WABASHA PLANNING COMMISSION

SUBJECT: Amendment to Solar CUP

Amendment to Solar CUP 1712 Hiawatha Dr. East

To: Wabasha Planning Commission
From: Harry Davis, AICP
Date: October 5, 2020
Subject: CUP Amendment Application – IPS Development, LLC

SITE PLAN

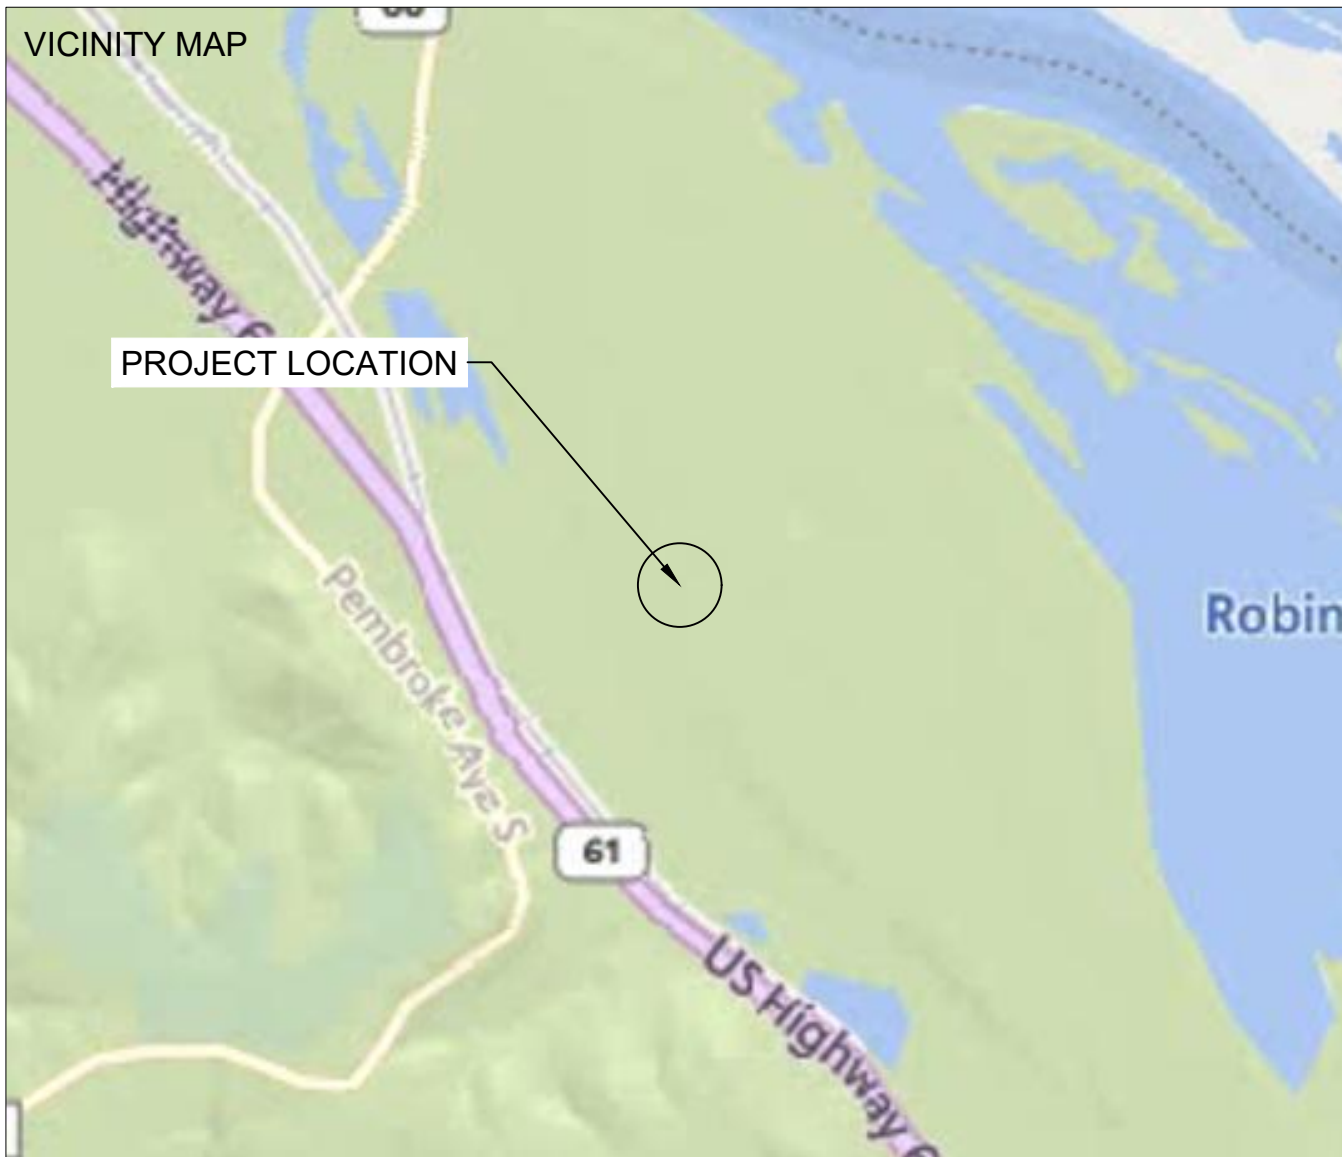
- Building inspector will certify the design as part of the building permit.
- Site plan shows a 15' wide drive to access the site. It is unclear the material proposed for the drive.

- No grading plan has been included in the application material. Ordinance states that Planning Commissioners may require one. Either way, the applicant will need to submit a grading plan and have it approved prior to starting development.

- It appears the large parcel already includes principal residential structures on the east side of the property. Adding a 1 MW solar garden would add an additional principal use to the property. The applicant should think critically about any subdivision that will be done as part of this project. It may be in the applicant's best interest to do so for tax reasons. If a subdivision were to occur, impervious surface coverage would need to be considered.

- A 8 foot galvanized fence is proposed for safety and security. Screening in the form of spruce evergreens are also proposed on the north lot line and along the eastern fence, mitigating any visual effects on residential properties. The tree line appears that is would mostly block views, but additional plantings are required by ordinance along the southern fence line since the adjacent lot is a residential zoning district. The applicant is required by ordinance to submit a maintenance plan for screening and will be need to be submitted prior to starting development. Planning Commission may discuss if they could/should require it prior to approval of the CUP amendment.

- Applicant should confirm that all on-site power will be buried so as to meet ordinance standards.
- The ordinance requires solar structures to be planted at the same elevation to each other. No grading plan has been submitted, so staff is unable to verify if this requirement can be met. The ordinance also requires a 100-foot setback from all property lines for solar structures. Planning Commission should discuss how the applicant could/should meet this requirement and if compliance is warranted given the original CUP did not have to meet these new requirements.

- 1) All performance standards for a solar garden/farm are met, with the exception of those outlined below.
- 2) Additional evergreens should be planted along the northern, eastern, and southern fence lines to screen the solar array from view. A maintenance plan for the fence and evergreens shall be submitted prior to starting development.

- 5) A grading plan must be approved by the City Engineer prior to the start of construction for the project.
- 6) A PE must verify the floodwaters in this area would not be excessive or dangerous to life and property.
